**DOCKET NUMBER 50-483  
UNION ELECTRIC COMPANY  
CALLAWAY PLANT**

**TECHNICAL SPECIFICATION REVISIONS ASSOCIATED WITH THE  
STEAM GENERATOR REPLACEMENT PROJECT**

RESPONSE TO REQUEST FOR ADDITIONAL INFORMATION

RELATED TO THE CALLAWAY STEAM GENERATOR REPLACEMENT

FIGURE 7.2-1  
FUNCTIONAL DIAGRAMS  
(PRIMARY COOLANT SYSTEM  
TRIP SIGNALS)

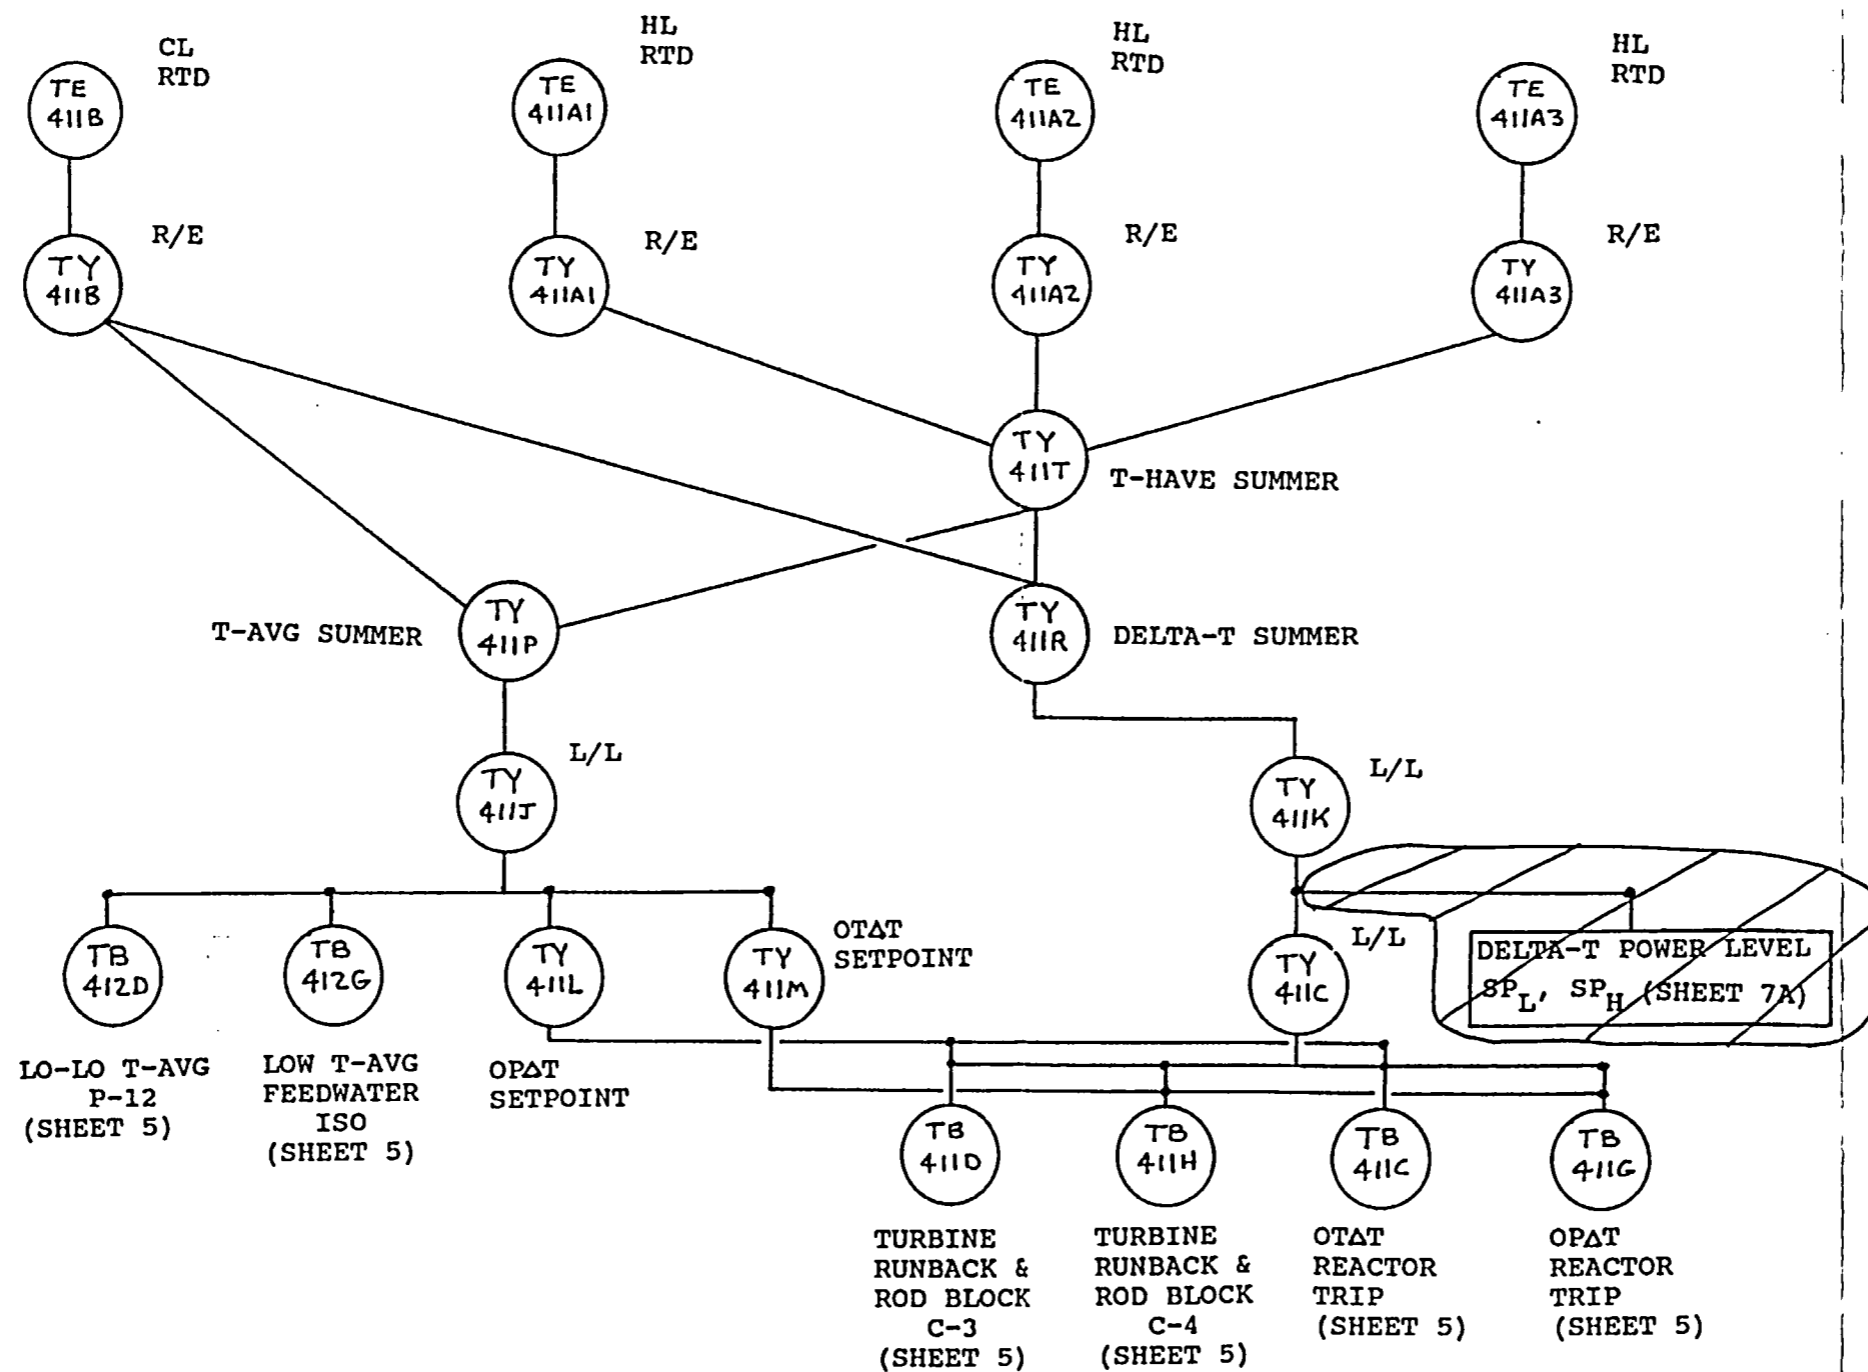
3. In Attachment 1 to the application, Page 7 of 51, Section 3.2, "TTD Elimination," states that upon NRC approval of the amendment request, the 7300 Process Protection System will be modified to eliminate the trip time delay (TTD) circuitry. Provide detailed justification and related protection system logic changes including any markup drawings for the proposed changes. Is there any precedent for these changes?

Enclosure 2 to this letter includes mark-ups to the simplified circuit diagrams in FSAR Section 7.2. In addition, Enclosure 2 also includes changes to one functional diagram and one process control block diagram that provide additional information regarding the TTD circuitry elimination.
